To:	Teri Camery (CBJ)	Date:	April 27, 2022
c:	Alix Pierce (CBJ)	Memo No.:	2
From:	Rita Kors-Olthof, Vladislav Roujanski, Shirley McCuaig	File:	704-ENG.EARC03168-01 / 704-ENG.EARC03168-02A
Subject:	Landslide Designations and Boundaries – Bathe Creek and Highlands Downtown Juneau Landslide and Avalanche Hazard Assessment

2.0 LANDSLIDE DESIGNATIONS AND BOUNDARIES

Figure 1: Excerpts from Figure 2.2c Avalanche Path Mapping Detail (Figure 1A) and Figure 2.3a Avalanche Hazard Designation Mapping Overview (Figure 1B).

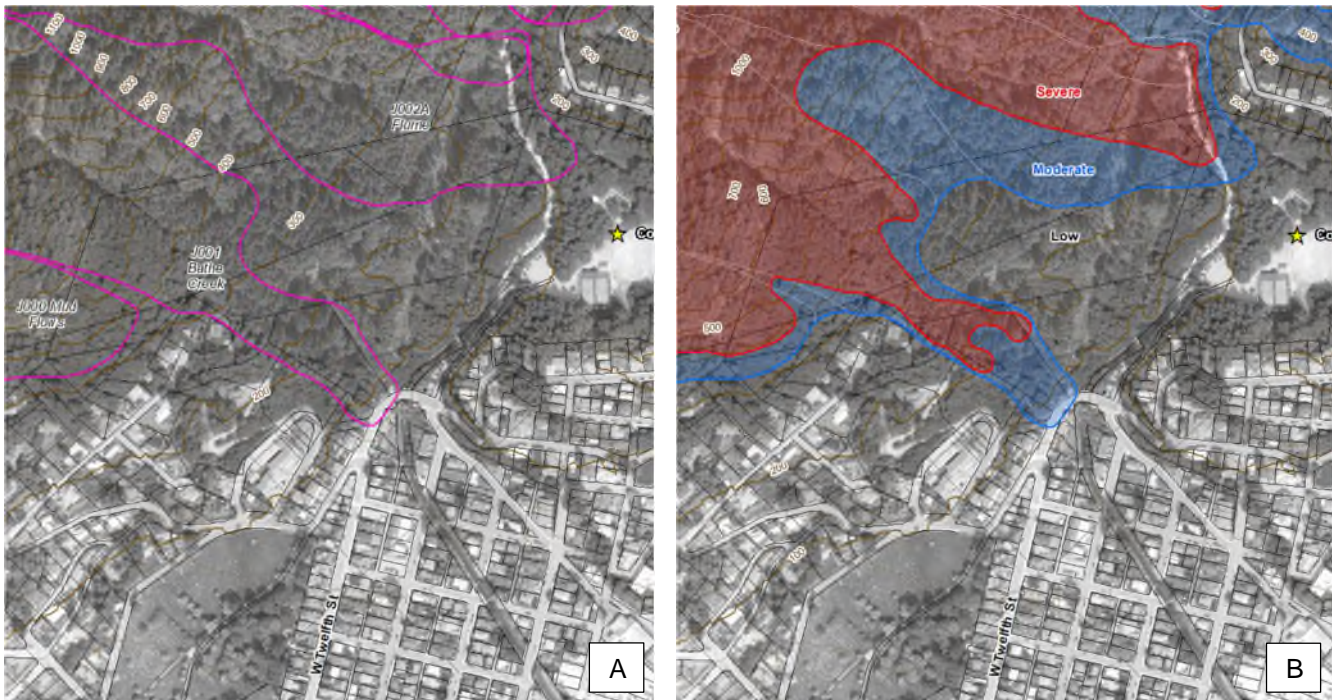
6. **Question/Comment:** The mapped boundaries [of the *Severe* hazard zone] are noted to be irregular, with curlicues and projections on the [east] side that do not resemble the mapped lobate avalanche boundaries, which may better define the landslide hazard area.

Response: See response to Item 3 above regarding the irregular “curlicues and “projections.” Bathe Creek is an example of where adjacent terrain units affect the shape of this terrain unit. In general, because the processes are not the same, avalanche path boundaries should not be expected to match landslide hazard boundaries. Compare the excerpts from the avalanche path and hazard mapping in Figures 2.2c and 2.3a (Figure 1 below) with the surficial geology and major gully features in Figures 1.3b and 1.5b (Figure 2 below). The boundaries of wet avalanches might sometimes approximate the boundaries of debris flows in the same terrain feature, a resemblance that would necessarily depend on the size and mobility of each event. In this case, they could be similar but not identical.

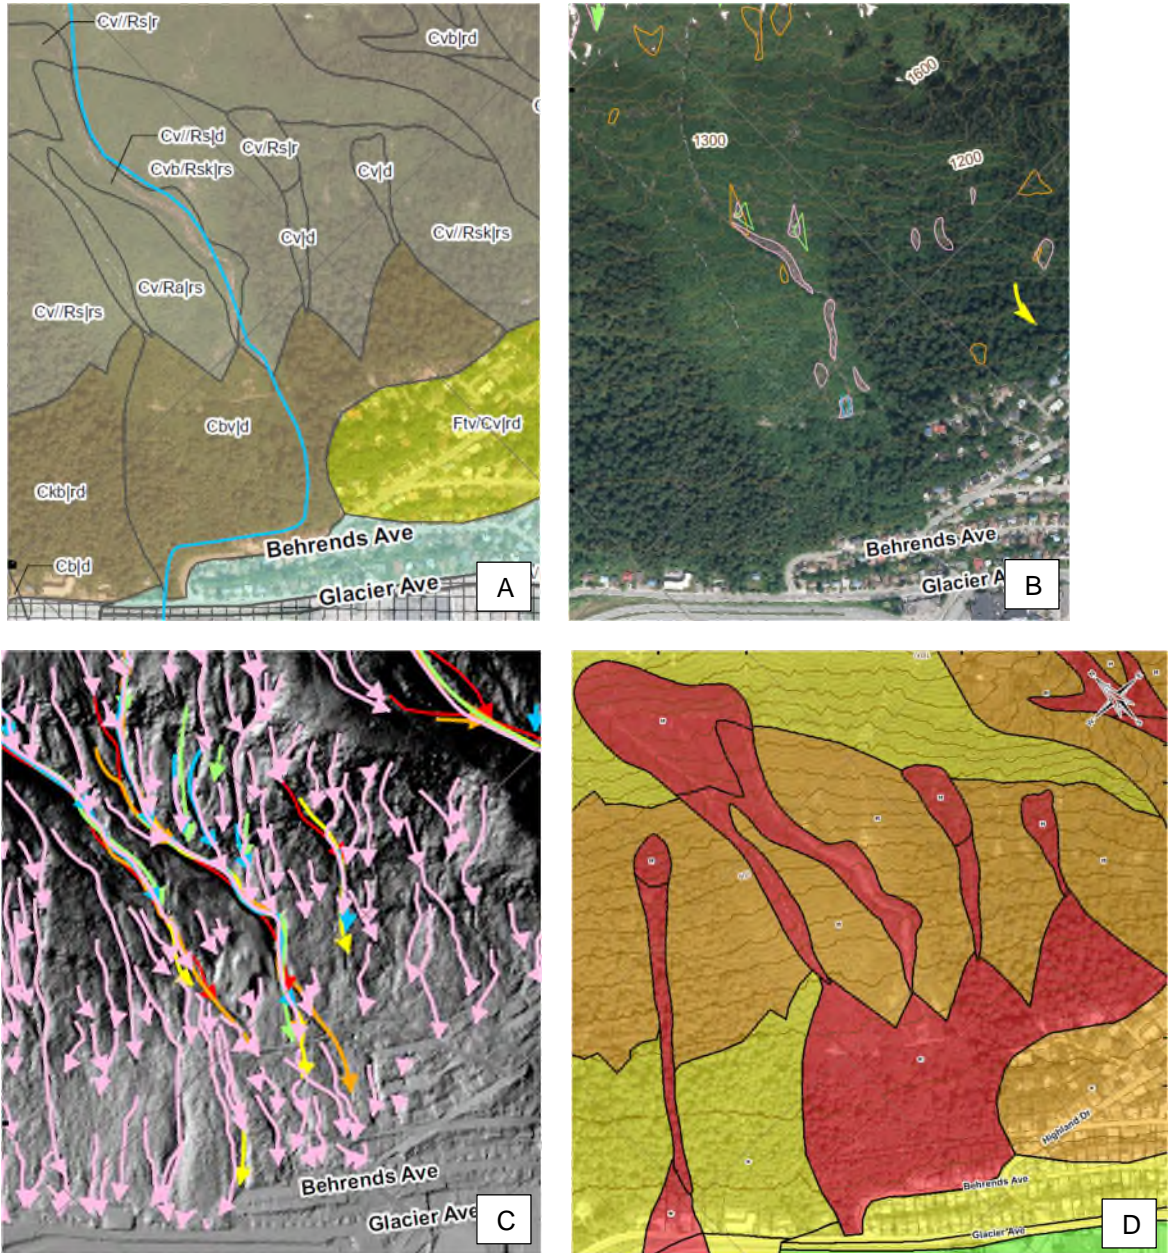
9. **Question/Comment:** The [west] side of the *Severe* hazard zone is noted to include a large area of colluvium in the Irwin Street to Highlands area, despite no recorded slide history since houses were built there. If the Swanston (1972) study is intended to support the *Severe* designation, maps and quotes from that study should be included in the report.

Response: The basis for the *Severe* hazard designation is not Swanston’s report, but rather Tetra Tech’s independent determination of the characteristics of the terrain units based on surficial geology mapping, historical air photo record analysis of slope movement features and gully erosion features, as well as incident reports and field observations. See also responses to Items 1 and 4 above. Specific to the *Severe* areas mapped in this part of the study area (Figure 1.6b and 1.6c), these are all colluvial areas (Figure 1.3b) that receive debris from several active gullies upslope (Figure 1.5b), including the previously mentioned Bathe Creek gully (see Figure 2 above), and several active gullies above Behrends Avenue and the west end of Highland Drive (see Figure 3 below). Several of the two dozen debris slides that occurred in various years in the immediate map area (Figure 1.4b) happened within gullies (compare Figures 3B and 3C below). The excerpt from Figure 1.4b (Figure 3B below) is also a good example of an avalanche track (area with no trees) that does not correspond perfectly with landslide activity and location.
